BWR EMERGENCY PROCEDURE GUIDELINES

REVISION 2

ERRATA 9/28/82

These errata make the following minor changes and corrections to the BWR Emergency Procedure Guidelines, Revision 2, a prepublication draft of which was submitted to the NRC on June 1, 1982:

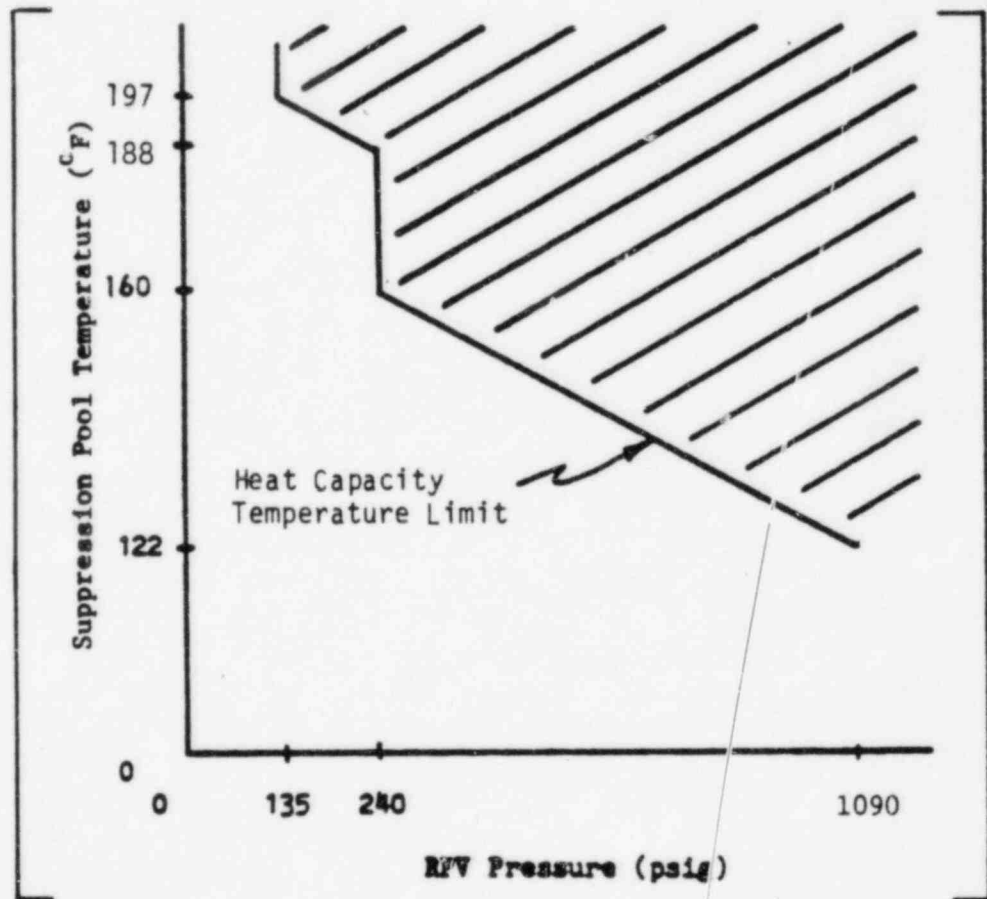
2. The superfluous conjunction, "or", has been deleted from each entry condition in the RPV Control Guideline.
3. The Heat Capacity Temperature Limit high endpoint pressure calculated for the typical plant has been corrected from 1020 to 1090 psig.

SP/T-4 If suppression pool temperature cannot be maintained below the Heat Capacity Temperature Limit, maintain RPV pressure below the Limit.
